UNITED STATES PATENT AND TRADEMARK OFFICE

APPLICATION NO.	FILING DATE	FIRST NAMED INVENTOR	ATTORNEY DOCKET NO.	CONFIRMATION NO.
10/813,084	03/31/2004	Maged M. Ghoneima	INTEL-0065	5661

Office Action Summary	Application No. 10/813,084	Applicant(s) GHONEIMA ET AL.	
	Examiner Howard L. Williams	Art Unit 2819

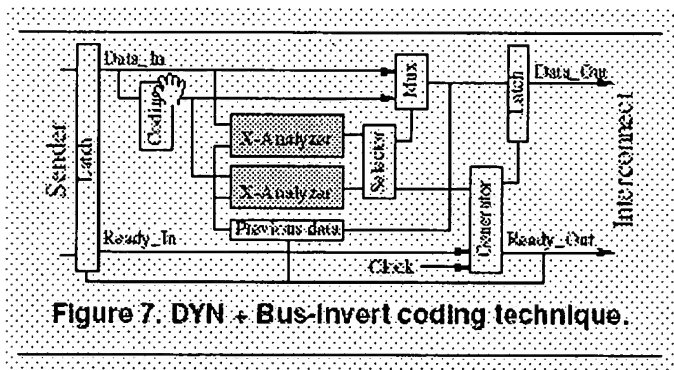
Li discloses in figure 7 a DYN + Bus Invert technique which either passes the data unchanged or selects the coding block via the mux for bus invert coding. Memory element for the input data is read upon the first latch (left side of figure 7) and flip-flops for delay insertion as the second set of latches coupled to the mux output. The “DYN”

or dynamic portion of the technique is described on page 2 left hand column first bullet where the method of analyzing the data to determine dynamically the number of clock cycles for transmission.
